# **REMEDIAL INVESTIGATION WORK PLAN FOR PER- AND POLYFLUOROALKYL SUBSTANCES (PFAS)**

## **AREA 3 FIELD SAMPLING PLAN**

### **ADDENDUM No. 1**

**FORMER FORT DEVENS ARMY INSTALLATION, DEVENS, MA**

AOC 31 Soil Sampling Results  
Devens PFAS RI – Area 3 PSCS

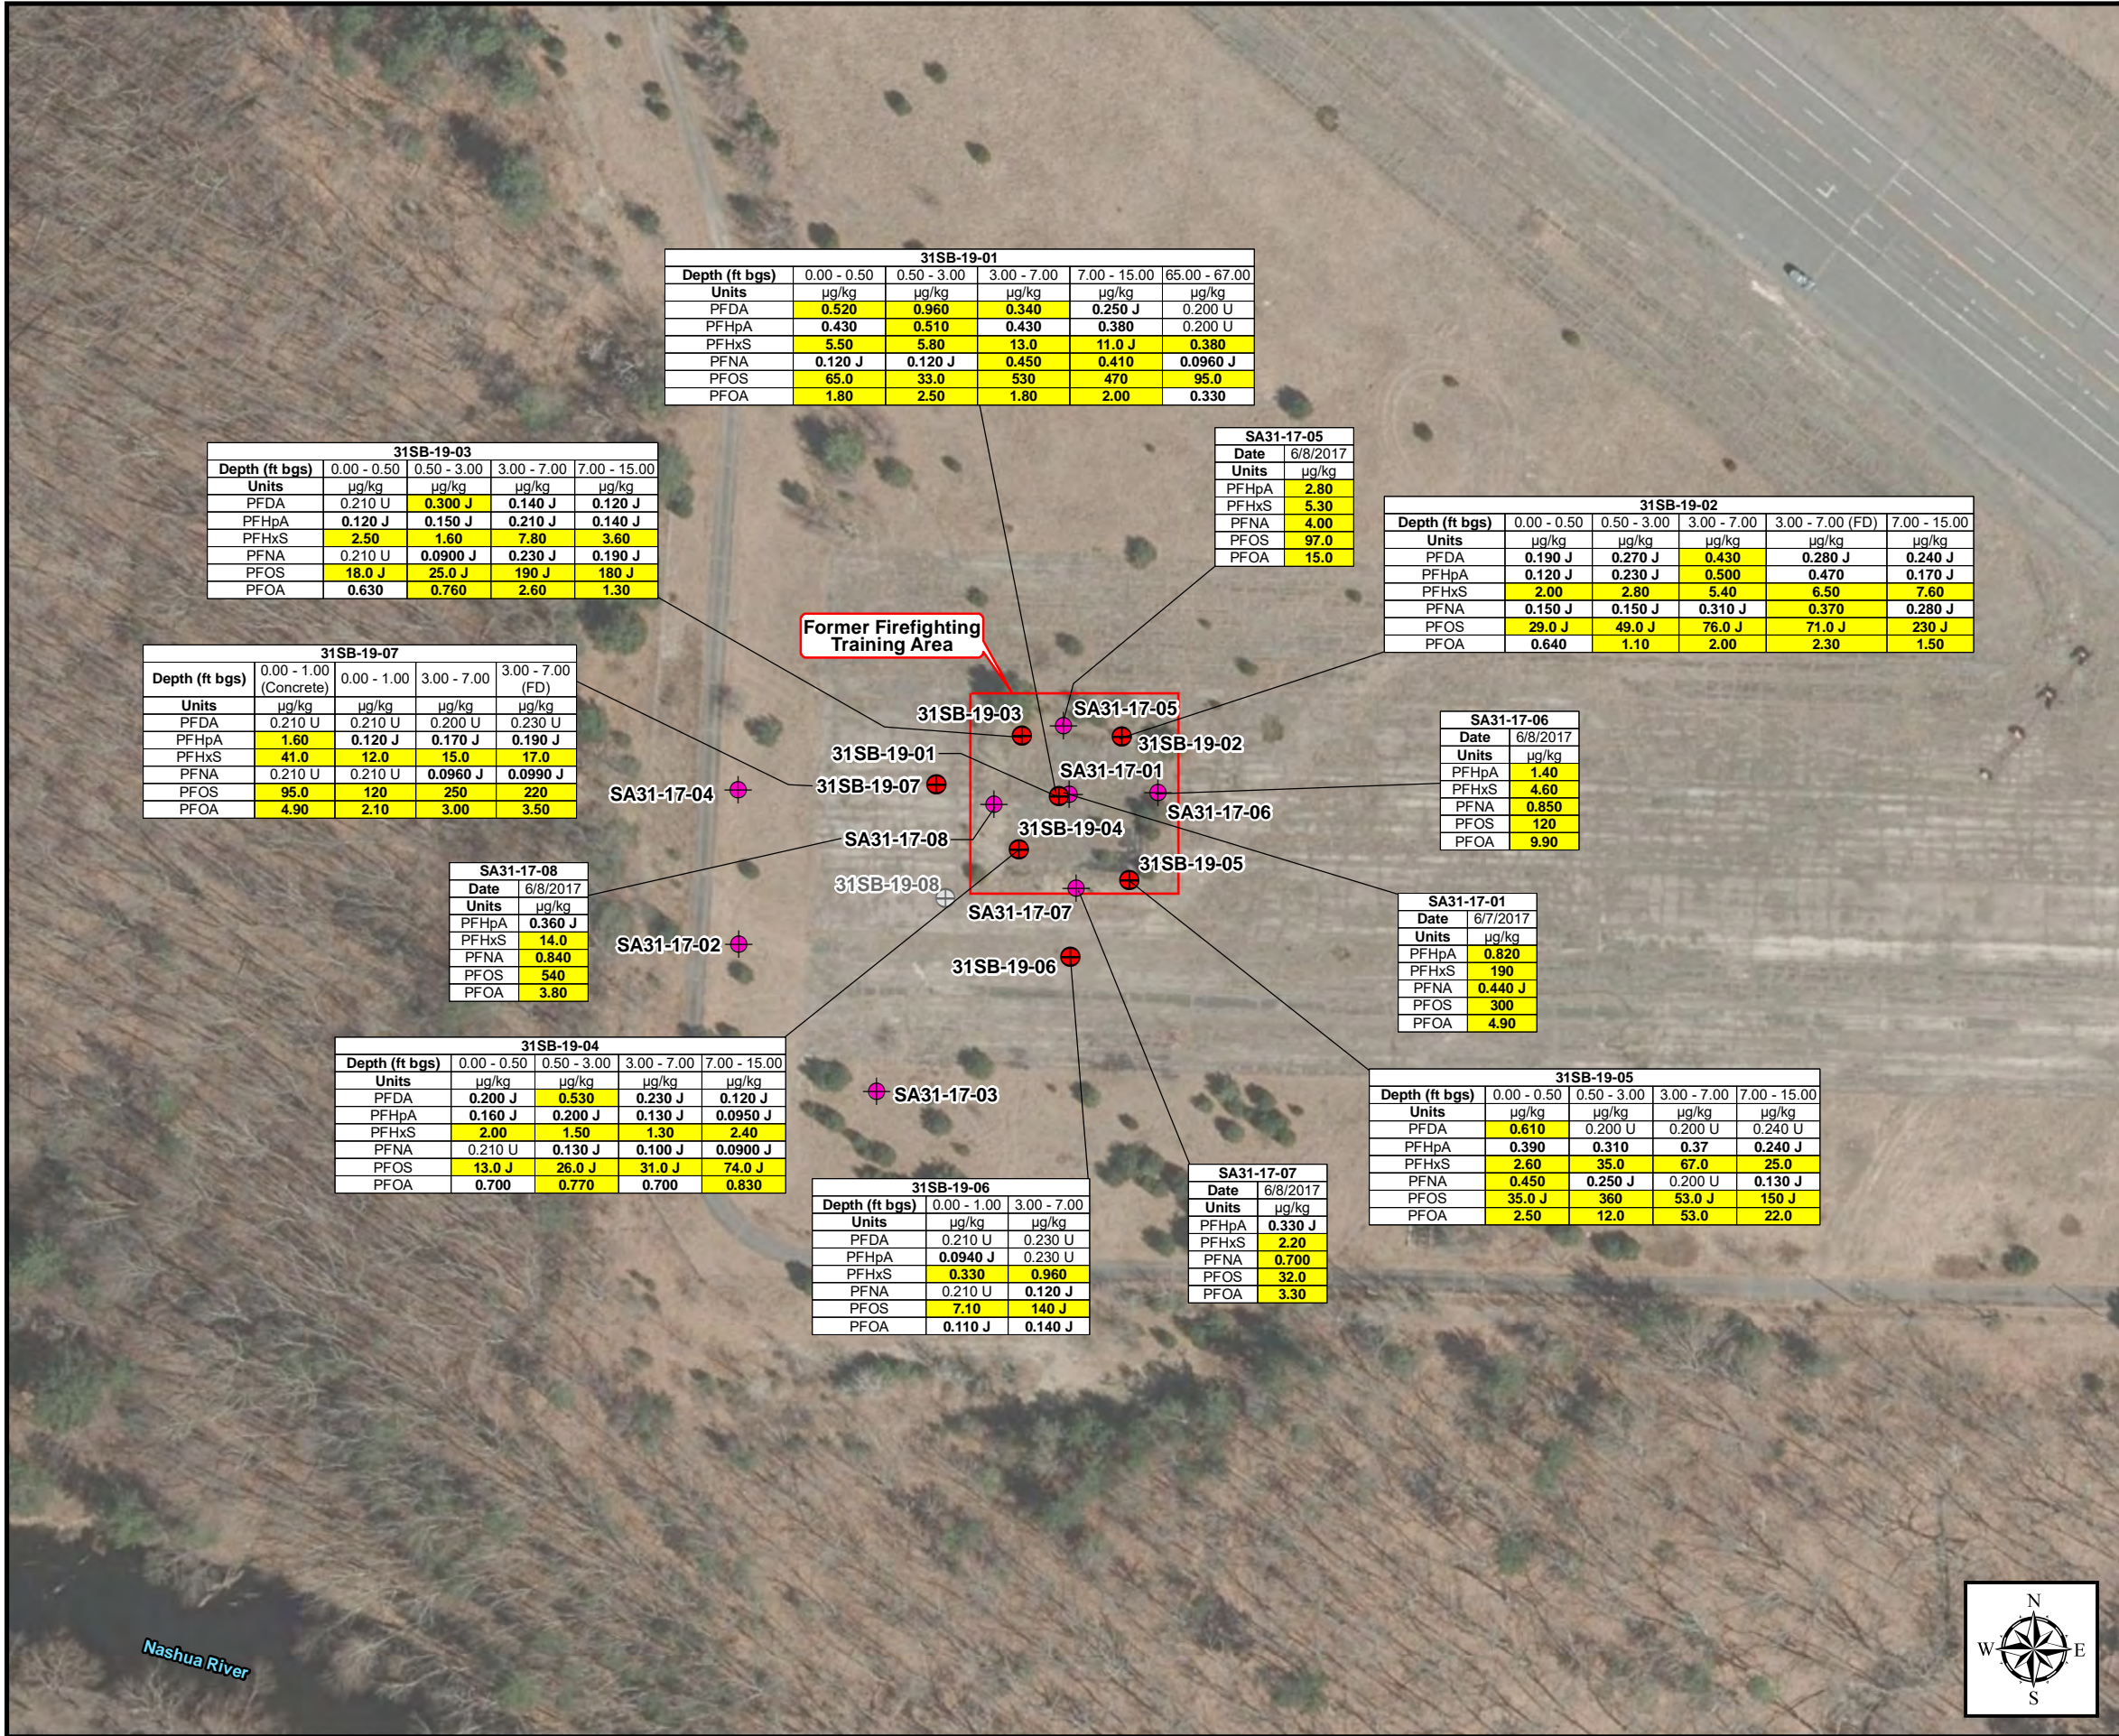
Project Name:	Former Fort Devens Army Installation	Date:	3 March 2022
Location:	Devens, Massachusetts	Reviewer:	EPA and MassDEP
Document Name:	Draft Remedial Investigation Work Plan for Per- and Polyfluoroalkyl Substances (PFAS), Area 3 Field Sampling Plan Addendum No. 1		
Prepared By:	KOMAN Government Solutions, LLC		
No.	Ref. Page / Para.	COMMENT	RESPONSE
<b>EPA Comments</b>			
1	Section 1.0, Introduction and Background	In light of the fact that the highest concentrations of PFOA and PFOS were detected in samples collected within AOC 30 – Former Fire Training Area, the draft FSP Addendum should be amended to include a brief discussion of prior sampling events and associated results. Specifically, results from soil and groundwater sampling conducted in conjunction with the PFAS SI, SSI and Phase 1 Area 3 RI should be discussed, and associated data summarized in a table to further support the sampling rationale in Table 1. (See May 22, 2018, Final SI Report and February 8, 2021, Area 3 Preliminary Site Characterization Summary (PSCS)).	A brief discussion and two figures will be added to the FSP: one figure summarizing prior sampling results performed for PFAS in soil and one summarizing prior sampling results performed for PFAS in groundwater.

AOC 31 Groundwater Results Devens PFAS RI – Area 3 PSCS			
Former Fort Devens Army Installation Devens, Massachusetts			
KOMAN Government Solutions, LLC 293 Boston Post Road West, Suite 100, Marlborough, MA 01752			
0 75 150 Feet	Date: 01/14/2021	Figure 2

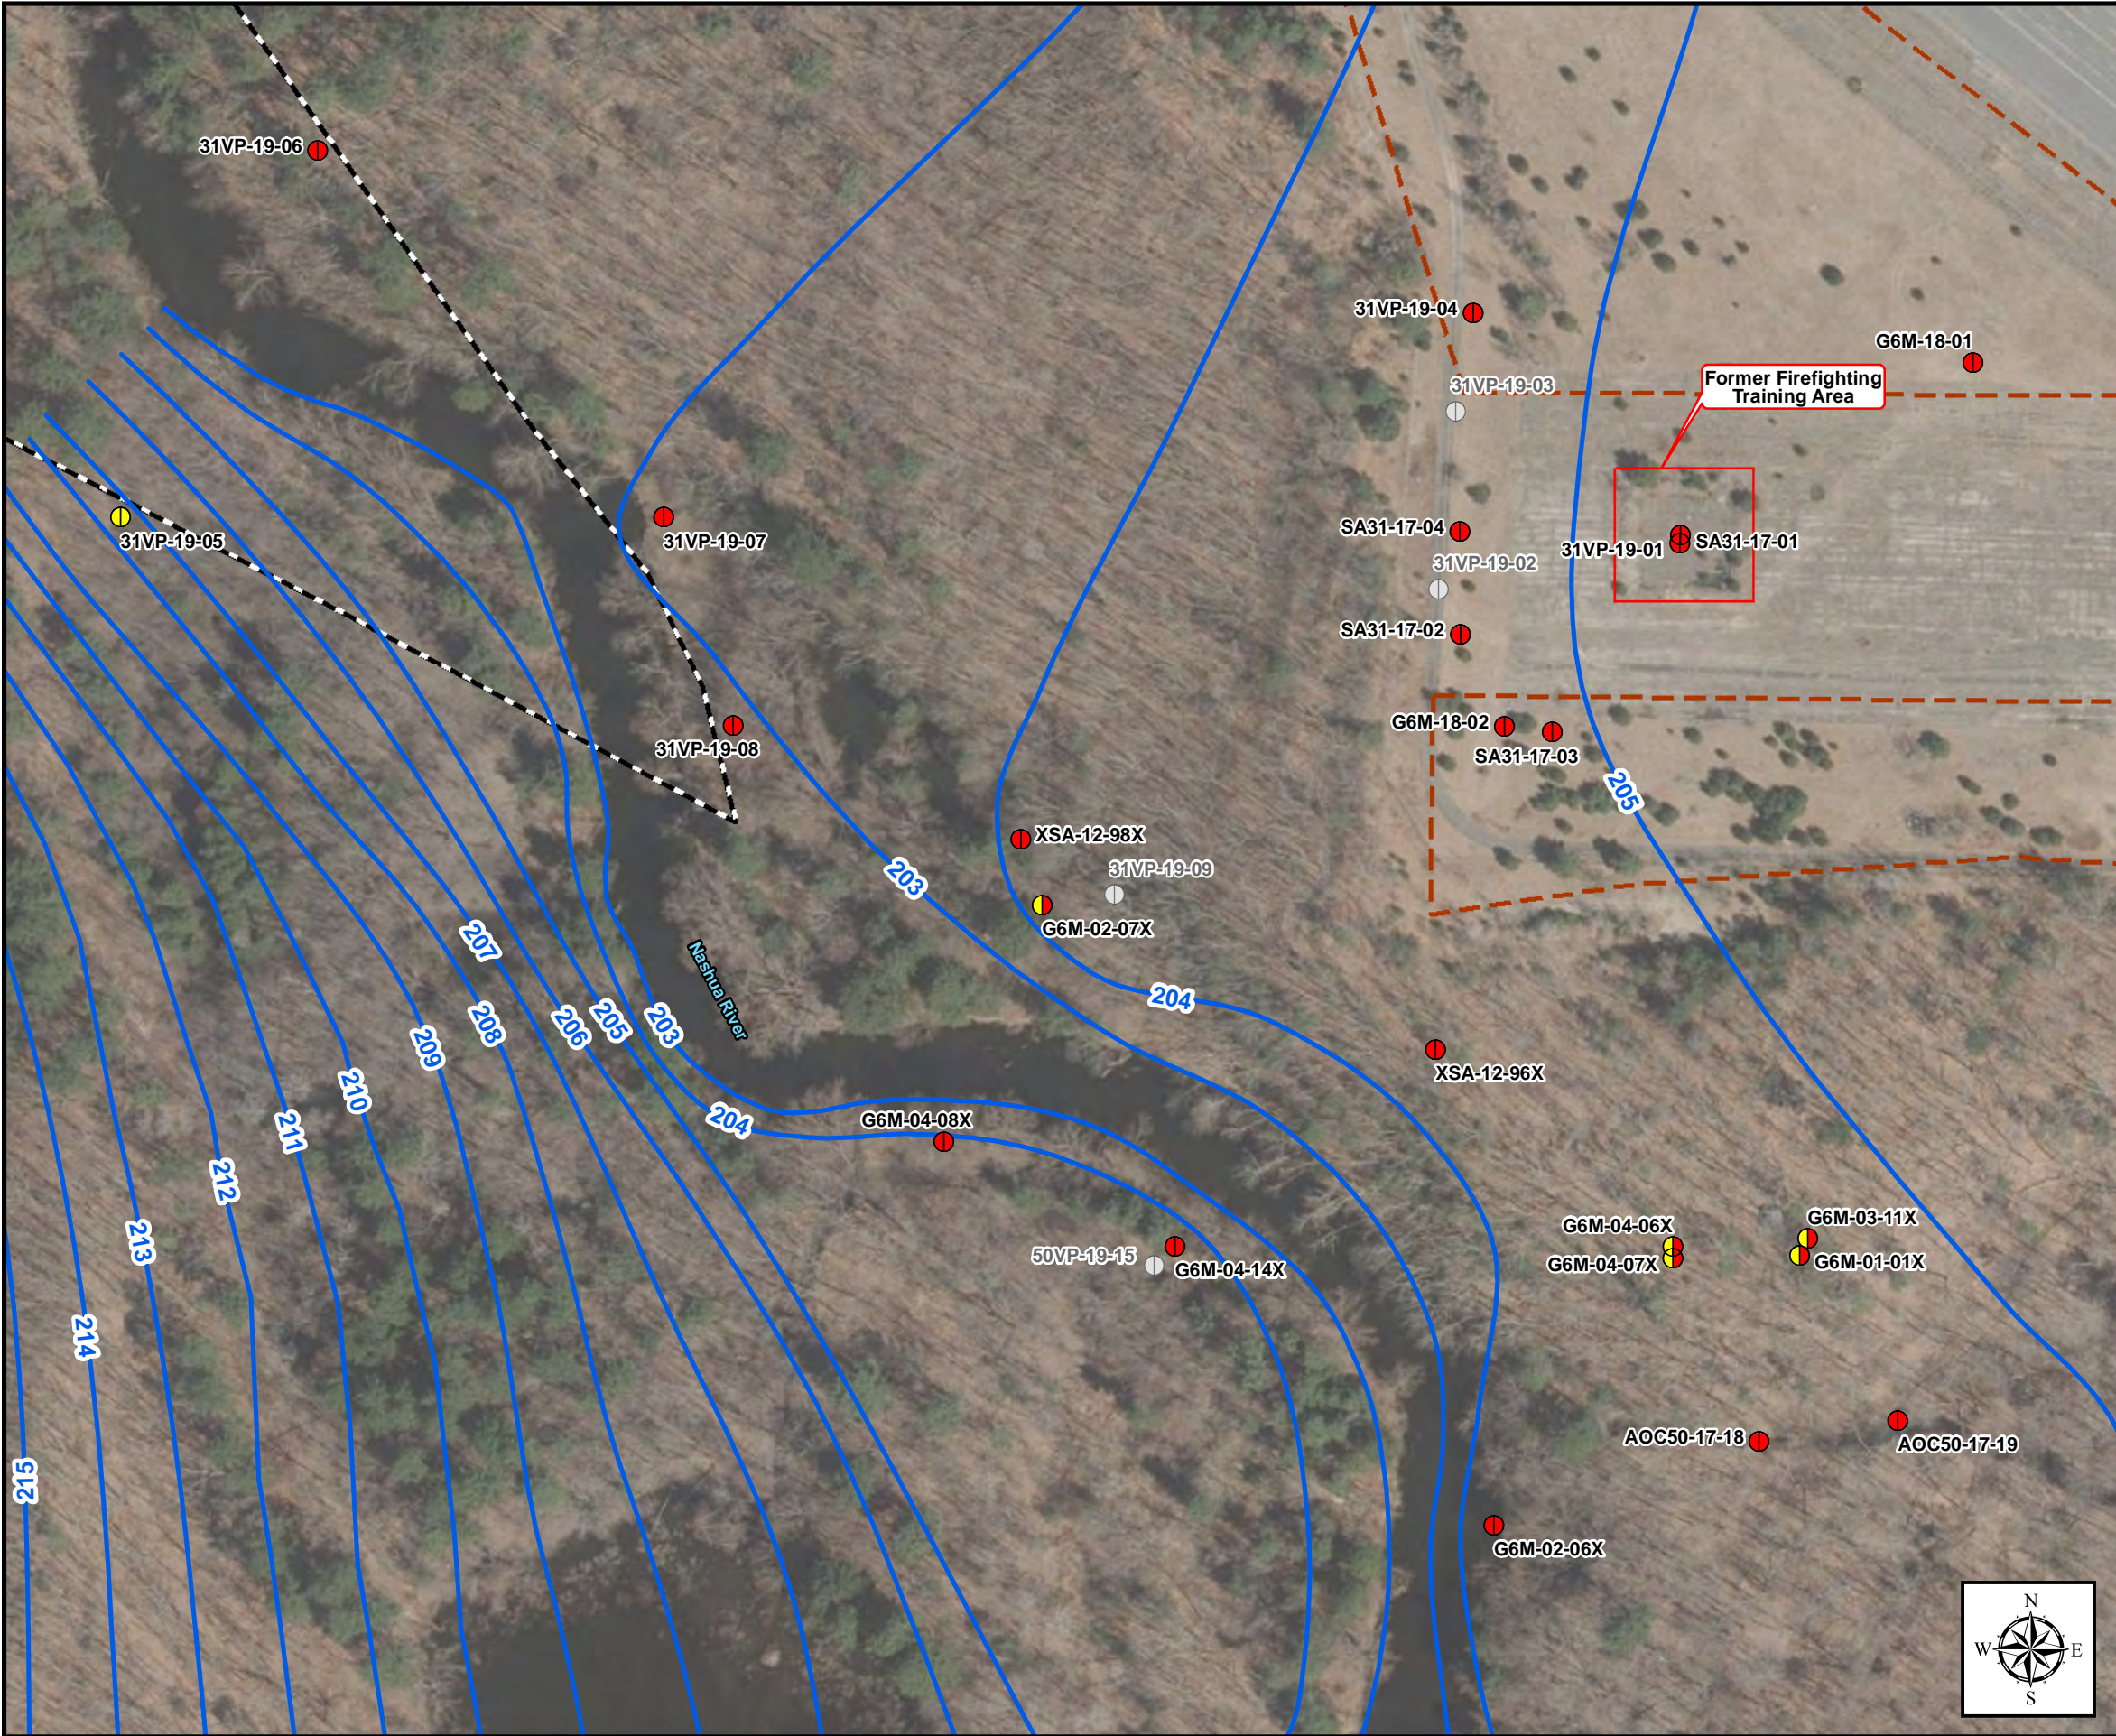
No.	Ref. Page / Para.	COMMENT	RESPONSE
			Prior to potential implementation of treatment in the AOC 31 area, the effect of that treatment on the surrounding area and the AOC 50 remedy would be evaluated.
4	Section 2.3, Groundwater Vertical Profiling	While it is part of the overall proposed groundwater sampling, the groundwater samples to be collected at the water table from the deep soil borings (31SB-21-01 through -13) do not fit the vertical profiling definition. For clarity, please add groundwater sampling to the section title or move that sampling to its own section.	The section will be renamed to Groundwater Sampling. The first sentence will be deleted. The new third sentence will be revised as follows: "At the vertical profiles, groundwater samples will be collected in 10-ft intervals from the water table to refusal."
5	Figures	For reasons discussed in comment 1. above, please add SI sample locations SA31-17-01, SA31-17-02, SA31-17-03, SA31-17-04, G6M-13-01X and G6M-02-07X and the six RI DPT vertical profile locations to this figure.	Locations SA31-17-01, SA31-17-02, SA31-17-03, SA31-17-04, 31VP-19-01, and 31VP-19-04 are shown on Figure 1 from the draft FSP. Labels will be added for these locations. G6M-13-01X is shown and labeled on Figure 1 from the draft FSP.  Locations G6M-02-07X, 31VP-19-05, -06, -07, -08 will be included in the groundwater results figure that will added to the FSP in response to EPA Comment #1.
